UNITED STATES PATENT AND TRADEMARK OFFICE

APPLICATION NO.	FILING DATE	FIRST NAMED INVENTOR	ATTORNEY DOCKET NO.	CONFIRMATION NO.
10/690,760	10/22/2003	Remigijus Gaska	SETI-0005	5376
23550	7590	01/21/2005	EXAMINER	
HOFFMAN WARNICK & D'ALESSANDRO, LLC			NGUYEN, THINH T	
3 E-COMM SQUARE			ART UNIT	
ALBANY, NY 12207			PAPER NUMBER	
			2818

Office Action Summary

DETAILED OFFICE ACTION

FIG. 2

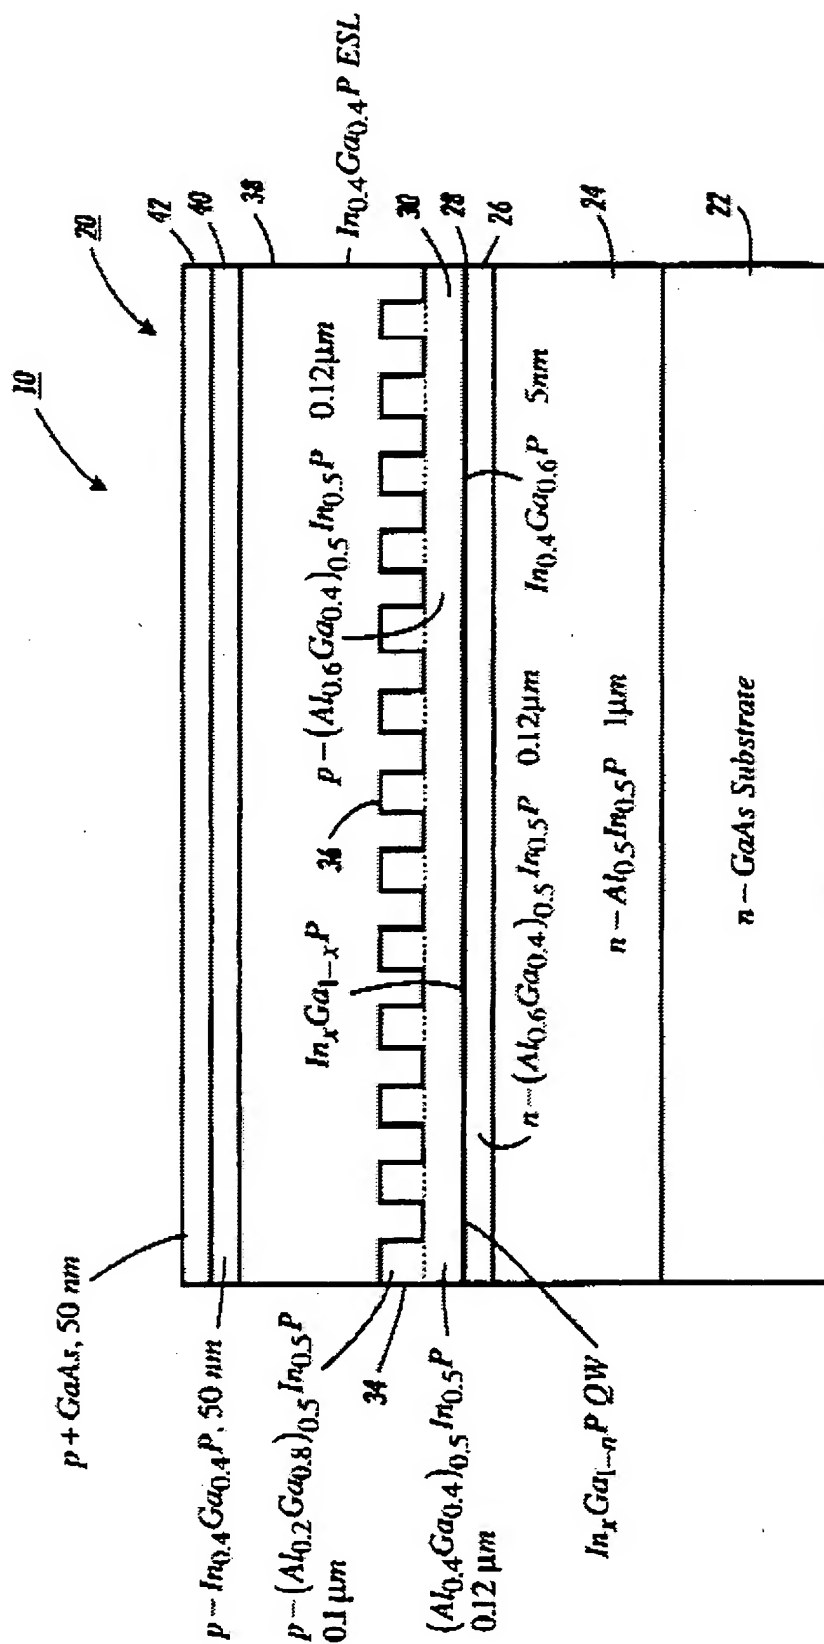
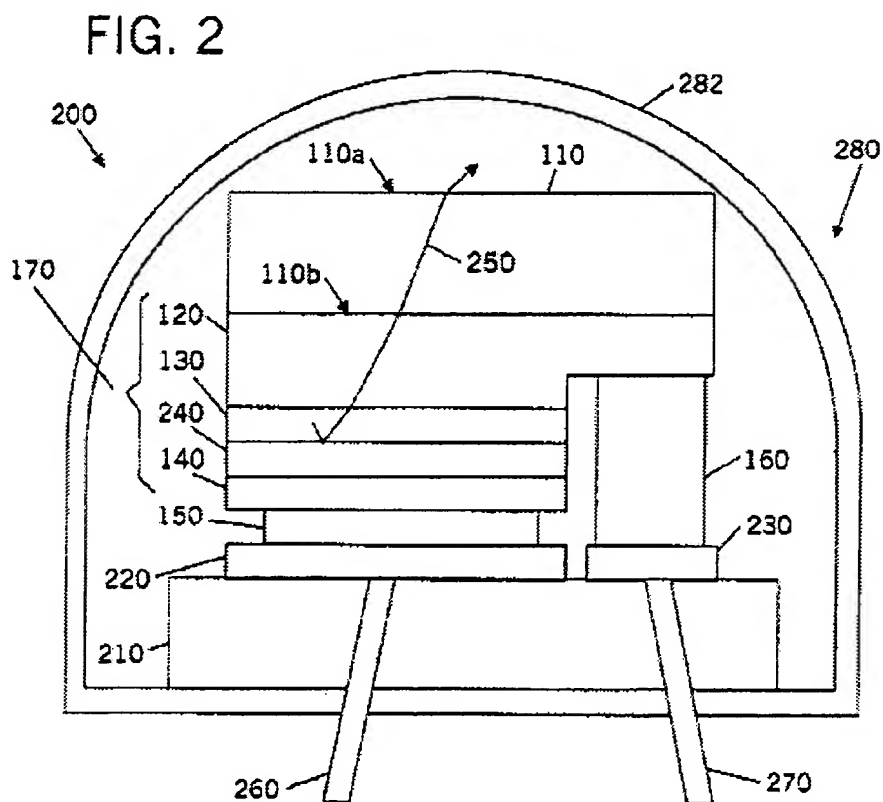
Sun (the abstract, fig 2) disclose a light emitting heterostructure comprising: a substrate (fig 2 layer 22) a light generating structure (fig 2 layer 28) formed over the substrate; a distributed semiconductor heterostructure Bragg reflector (DBR) structure formed (fig 2 reference 36) over the light generating structure; and a p-type layer (fig 2 layer 40) formed over the DBR structure .

And similarly , Slater, Jr. (the abstract, fig 2 with substrate layer 110, Bragg layer 240, p layer 140) discloses the same invention. Noted that the device of Slater is flip-chip mounted that means it is mounted upside down.

FIG. 3

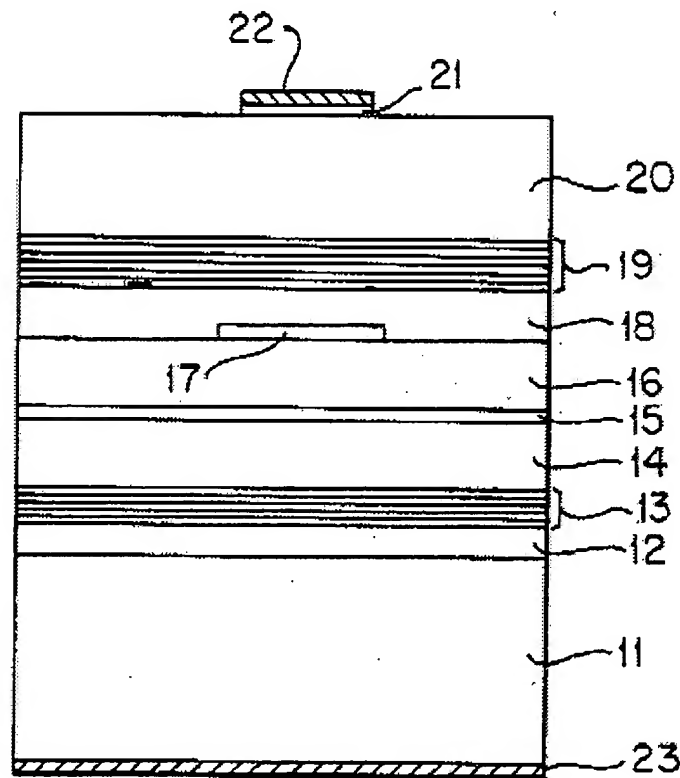
Sugawara (the abstract, fig 3) disclose a light emitting heterostructure comprising:
a substrate (fig 3 layer 11) a light generating structure (fig 3 layer 15) formed over the substrate; a distributed semiconductor heterostructure Bragg reflector (DBR) structure formed (fig 3 reference 19) over the light generating structure; and a p-type layer (fig 3 layer 40) formed over the DBR structure. Additionally, Sugawara disclose a current blocking layer (fig 3 layer 17).

Ueki also anticipates claim 2 since the Ueki reference disclose (fig 9(a), Column 16 line 15) insulation layer 43 which inherently serve as electron blocking layer.
